ORDINANCE 95-01

**TO AMEND THE BLOOMINGTON ZONING MAPS FROM RE to RS,
GRANT PUD DESIGNATION, AND APPROVE OUTLINE PLAN**

**Re: 3300 Leonard Springs Rd.
(Stephen Rumble, Petitioner)**

RE/PUD-69-94

OUTLINE PLAN EXHIBIT FOR CEDAR CHASE

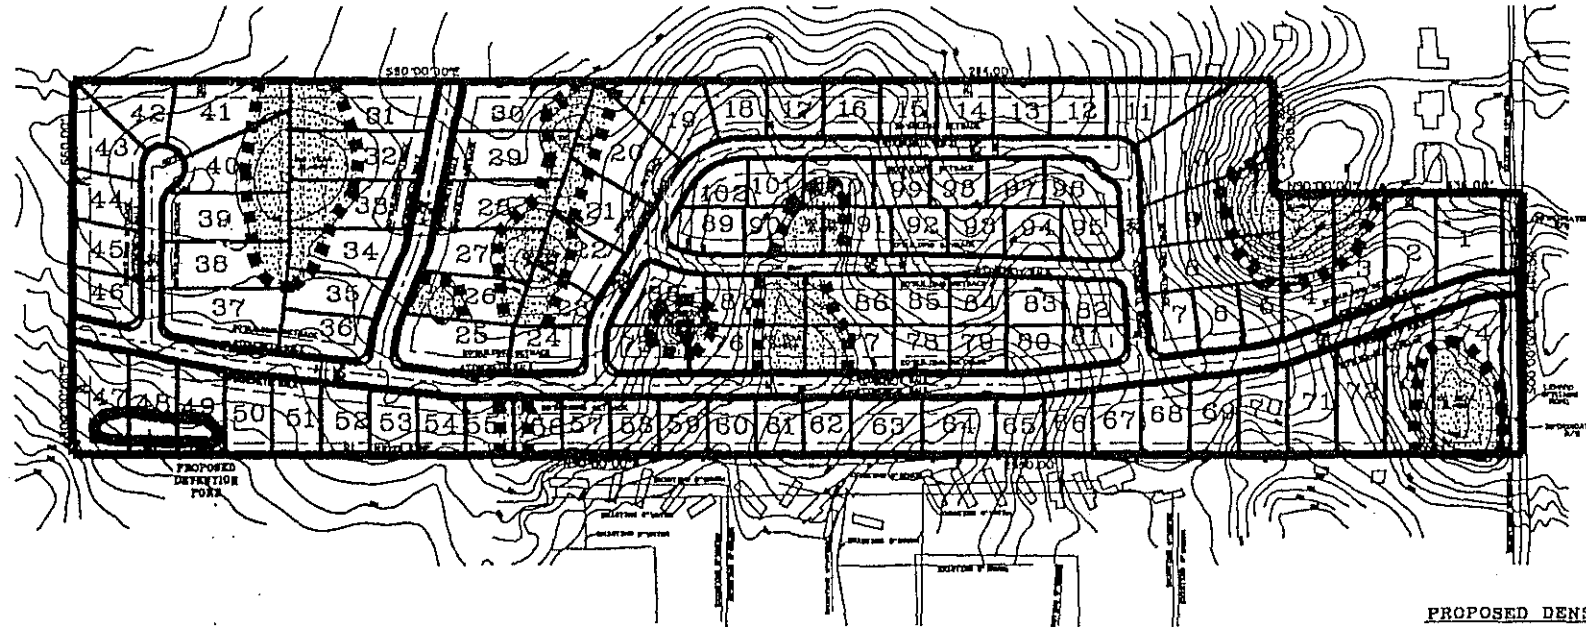
Grades: The current site plan identifies 8 sinkholes. With the boundaries delineated, it is difficult to see how a conventional structure might be placed upon Lots #73, #74, #88, #75, 100, #90, or #91. Additional sink holes have been identified by the petitioner. Staff will work with the petitioner to orient house sites on the proposed lots, and to address all of the known sinkholes.

Lot 74 - There are two sinkholes on this lot, one that will be a major drain on this site and another that is recommended by the consultants for no disturbance. The larger sinkhole is also classified as a special conservancy zone. There is technically room for a homesite on this lot but we are concerned about karst impacts.

Lots 89 and 102 - The consultant's report recommends avoiding building in the area of sinkhole #6a but the petitioner's plan shows these two lots plus a portion of the road in this area.

Lot 26 - This lot is framed by a karst valley at the rear and sinkhole #13 along the front. Again, it is feasible to place a home between the two karst features but maybe not advisable.

Lots 16, 83, 94 - All of these lots have small karst features on the buildable portions of their lots. Lots 16 and 94 have karst features that are recommended for no disturbance. It will be very important to accurately spot these karst areas to determine if building on these sites is advisable.
